Date: 9/27/13
 To: Build Development - Sydonia
 (Person's Name and Division)
 From: Jeremy Clancy 443,3401229
 (Your Name, Company Name and Telephone Number)
 Subject: Project name _____
 Project site address 14908 Meriwether Drive
 Permit Number 313 8442 SDP # _____
 (System down)
 Other information pertinent to this project _____

PLOT PLAN
 LOT #28
MERIWETHER FARMS

LIBER 12124, FOLIO 120
 PLAT No. 21769, ET SEQ.
 FOURTH ELECTION DISTRICT
 HOWARD COUNTY, MARYLAND

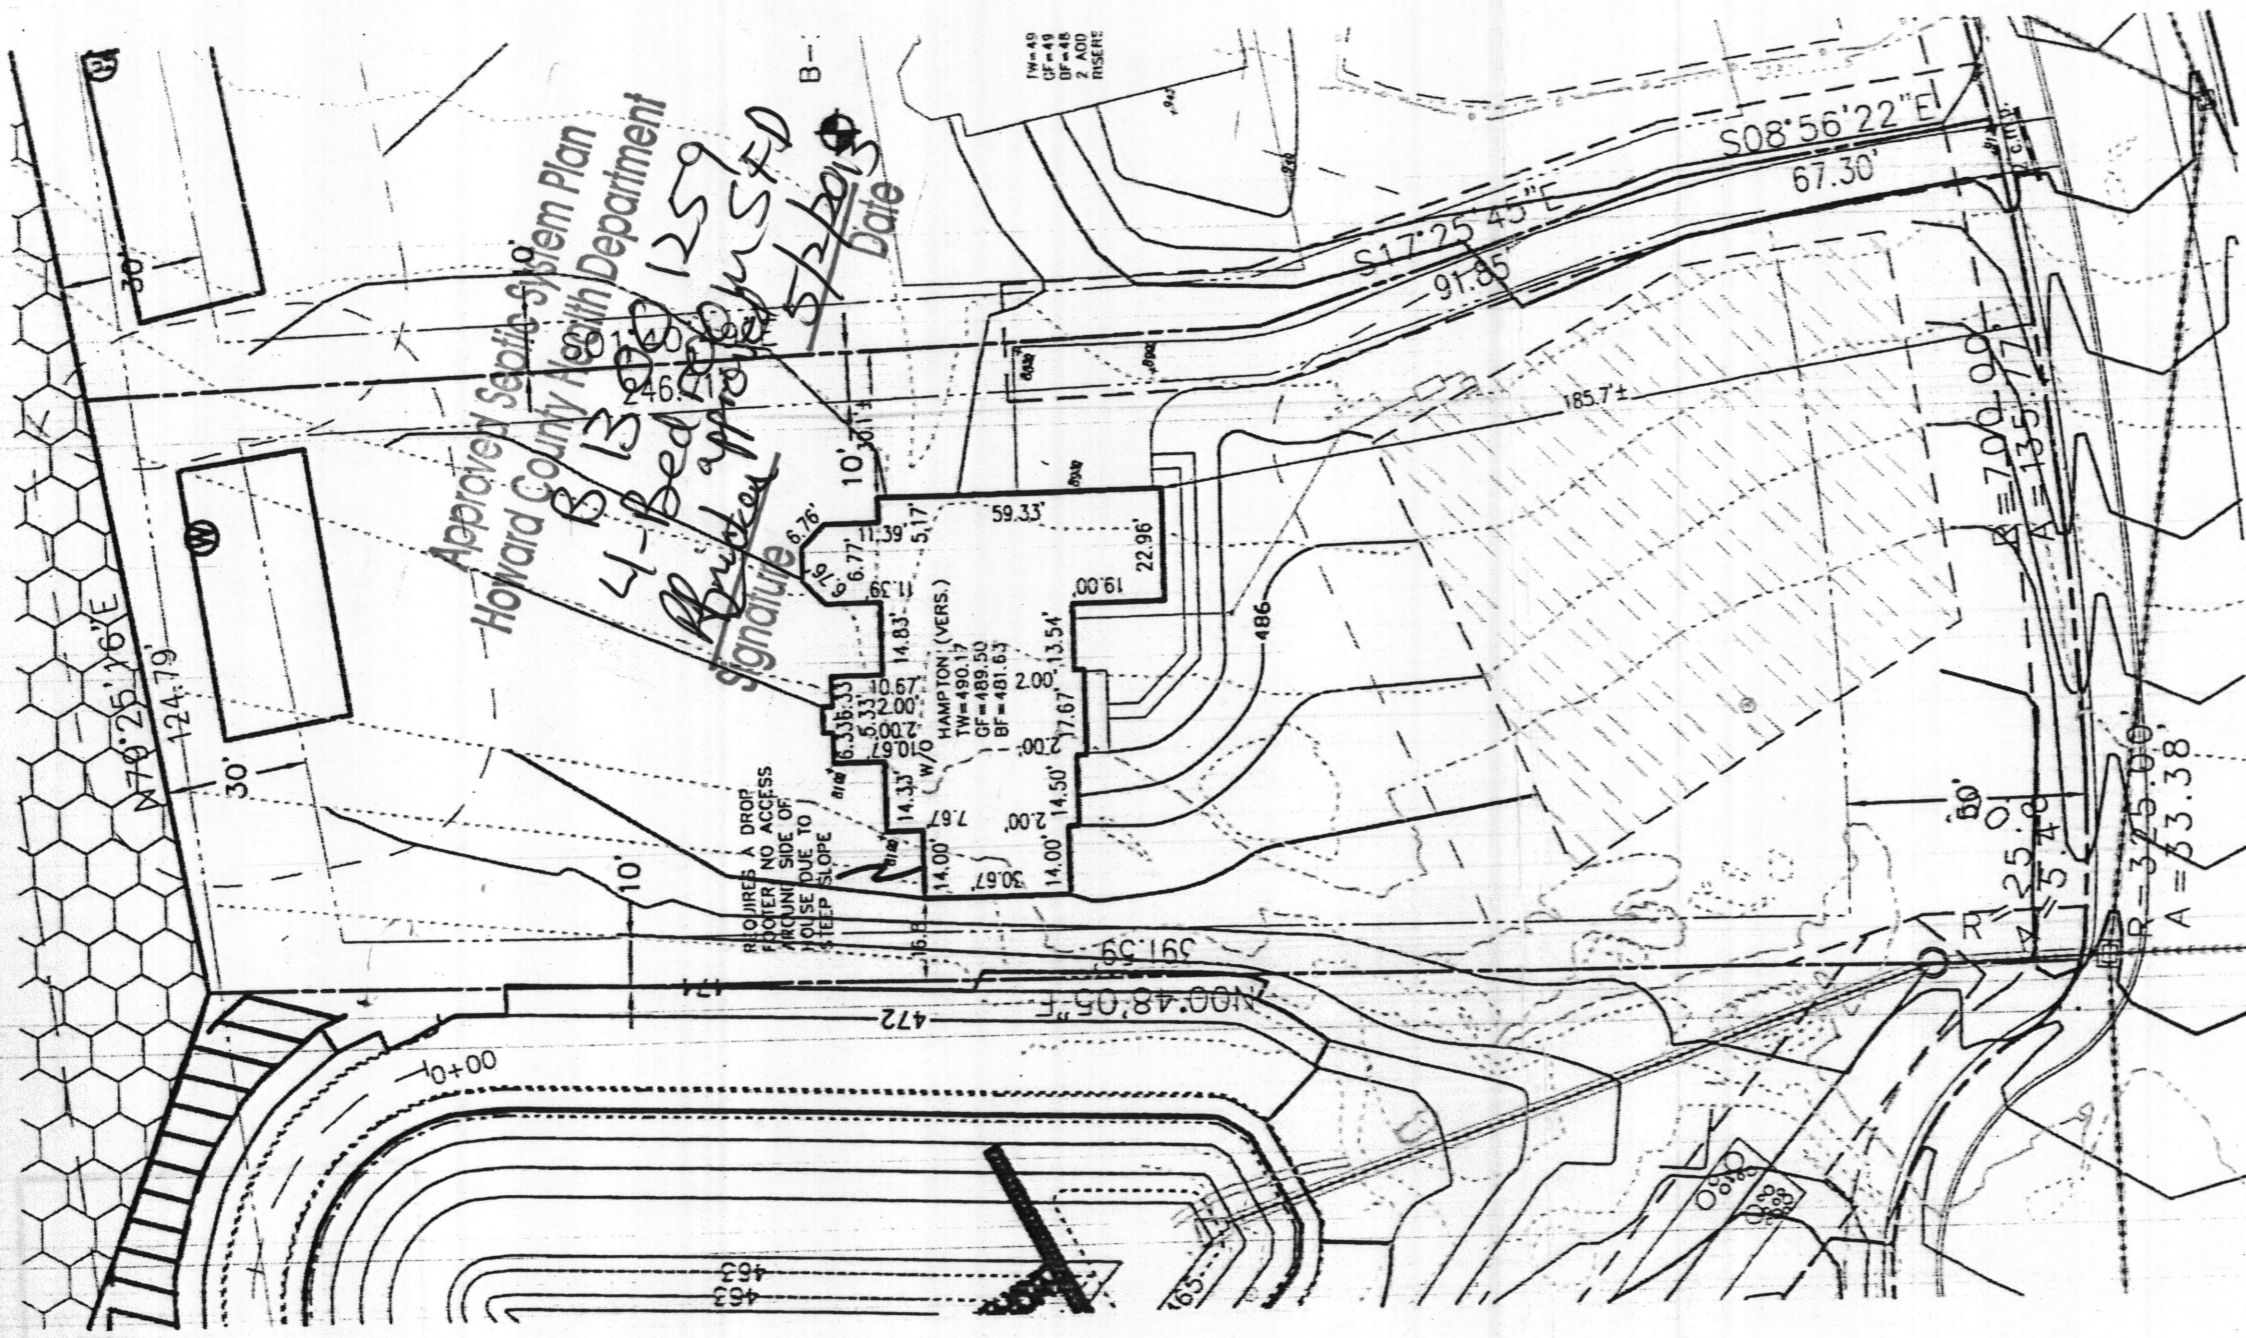
- Letter of response to Howard County plan review code letter
- Revised plans and/or revised details: When submitting for a complete re-review, **duplicate sets shall be submitted.**
Per comments tank location revised
- Structural steel certification
- Energy conservation calculations
- Certification for _____ (be specific).
- Copies of _____ (be specific).
- Two sets of single family dwelling model plans to be placed on permanent file: Model name and/or # _____
- Other _____
